**Notification of a Decision taken by the Cabinet Member for Housing,
Regeneration and the Climate Emergency**

Title of report: Melrose Avenue- Review of existing contra-flow cycle lane

Subject: Melrose Avenue-Review & modification of existing contra-flow cycle lane

MELROSE AVENUE- CONTRA-FLOW CYCLE LANE IMPROVEMENTS

Appendix 1- Newsletter / Plan

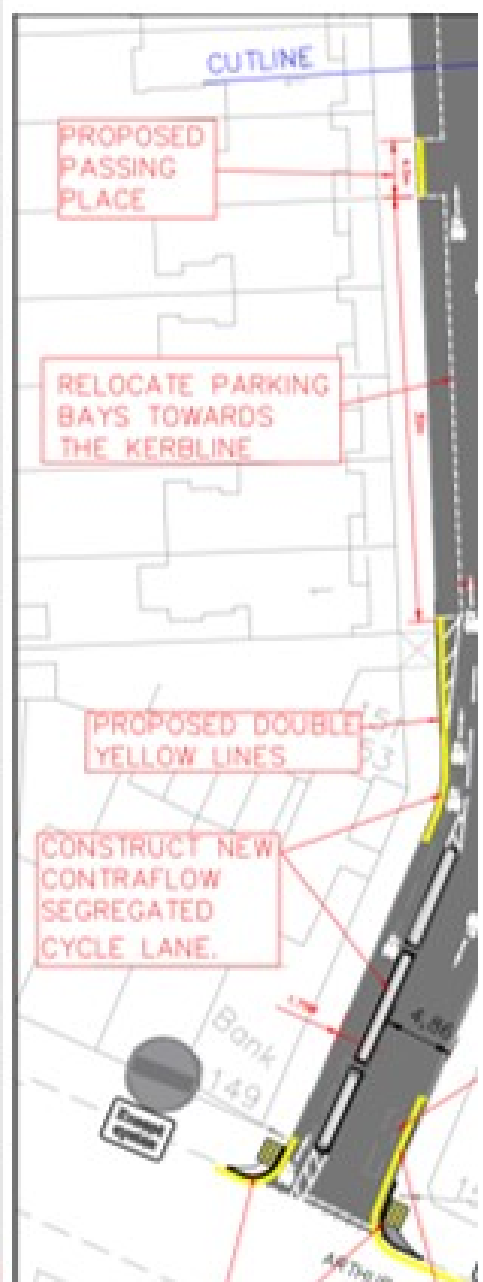
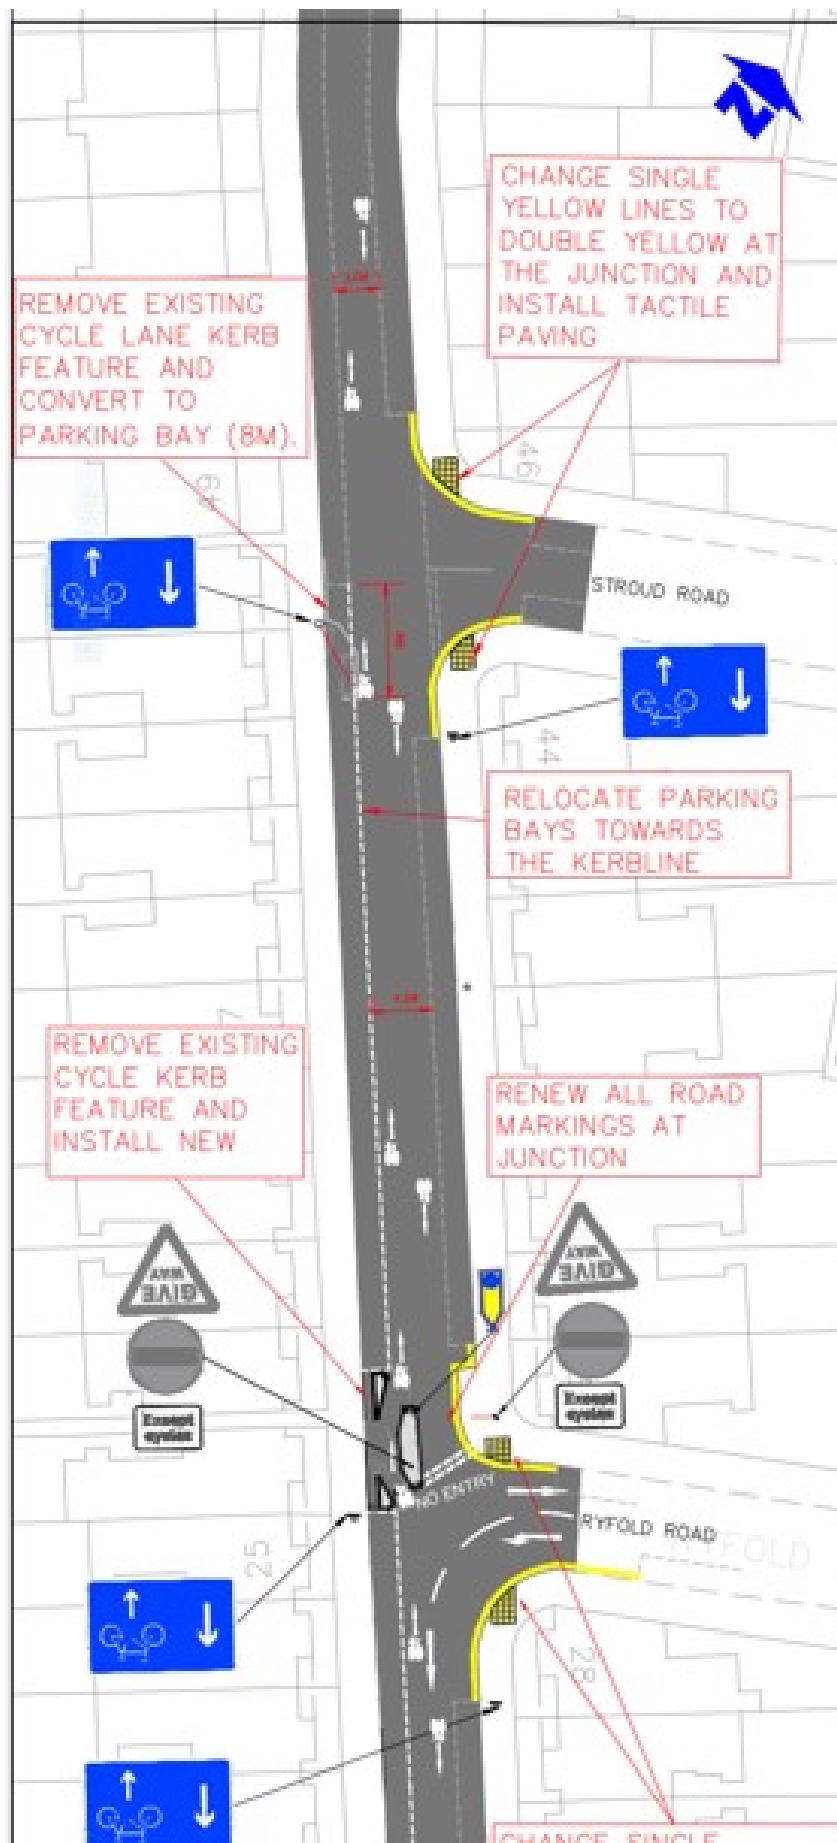
I cannot see any other measures on your plan that safeguard cyclists:

If the junction is being re-kerbed at the Arthur Rd end then the 4.86m wide space for drivers on the proposal could be much reduced and the footway should be made continuous to provide priority for people walking straight ahead as per this junction below.

Scheme drawing Merton Traffic and Highways 'General Layout 2022'

In 2019 Merton Cycling Campaign stated that when given the choice of a compromised segregated cycle lane or a compromised one-way street cycle contra-flow then cyclists choose segregation. Merton Cycling Campaign's objections remain as that 2019 statement (attached) which included support for the solution that was put forward by Merton's Consultants in 2004 for raising the existing contra-flow facility to footway level allowing for more cycling width. However we would like to add these additional points.

We estimate that a minimum of 1 in 10 of the parking places needs to be removed to make these breaks. Without the breaks cyclists will experience extreme discomfort being relentlessly squeezed against the flow of motor vehicles. It is therefore without question that the current proposal is not an improvement and might only
